SERVICE BULLETIN # 1012

SUBJECT Governor Wire Installation

MODEL **Attachments** DATE 2-5-58

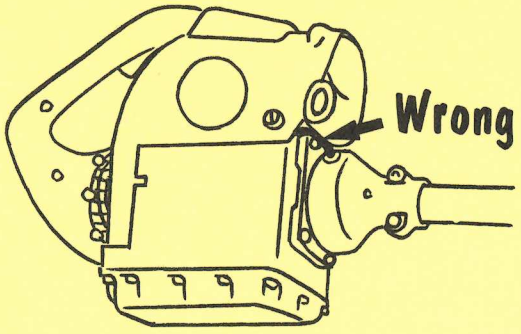
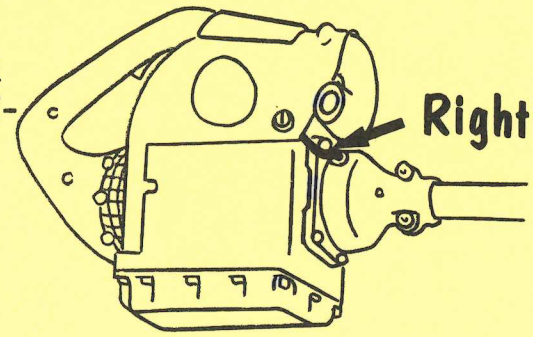
When the governor was first introduced on the Brushcutter Attachment, its wire assembly, part number 52149, was assembled so that it passed over the head of the housing retaining screw, part number 101982, on the side closest to the muffler, part number 36932.

It was discovered that heat from the muffler quickly burned through the insulation on the wire causing grounding of the wire and stopping of the engine.

To correct this condition, the governor wire is now passed under the retaining screw head on the side away from the muffler. It is suggested that any Brushcutter attachments received with the governor wire passing over the retaining screw head should have this condition corrected.
